Access Compliance Report Public Rights-of-Way (Curb Ramps)

Main Street: WEATHERBY_RD Cross Street: CORTESE_DR Location: NE

ADA ID: RPRK211217132440 Ramp Type: Type 4 - Parallel Initial Pass/Fail: Fail Overall Compliance: No Severity Score: 2

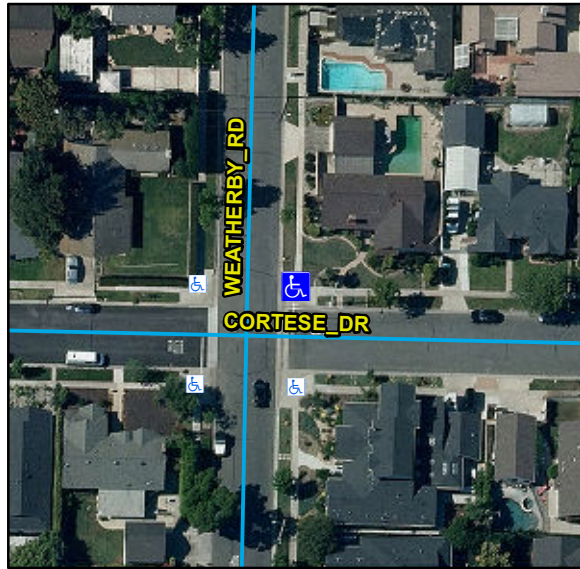
Compliance	Description	Data	Compliance	Description	Data
N/A	Ramp Length LT (in)	92	N/A	Ramp Length RT (in)	92
Yes	Ramp Width LT (in)	105	Yes	Ramp Width RT (in)	94
Yes	Ramp Run Slope LT (%)	5.6	Yes	Ramp Run Slope RT (%)	5.8
Yes	Ramp Cross Slope LT (%)	1.9	No	Ramp Cross Slope RT (%)	2.7
N/A	Landing Present	N/A	N/A	DWS Provided	N/A
N/A	Landing Length (in)	N/A	N/A	DWS Contrast	N/A
N/A	Landing Width (in)	N/A	N/A	DWS Length (in)	N/A
N/A	Landing Run Slope (%)	N/A	N/A	DWS Full Width	N/A
N/A	Landing Cross Slope (%)	N/A		DWS Offset Type	N/A
N/A	Landing Movement Obstructed?	N/A	N/A	DWS Offset Left (in)	N/A
	Landing Movement Type	N/A	N/A	DWS Offset Right (in)	N/A
N/A	Landing Shared	N/A			
N/A	Clear Space	Yes			
N/A	Clear Space To Crosswalk (in)	N/A			
N/A	Marked Crosswalk 1	No	N/A	Marked Crosswalk 2	No
	Crossing 1 Direction	W		Crossing 2 Direction	S
	Marked Crosswalk 1 Width (in)	N/A		Marked Crosswalk 2 Width (in)	N/A

Remove & Replace Curb Ramp With Two New Directional Ramps or Equivalent.

R304.5.3, STD 1115
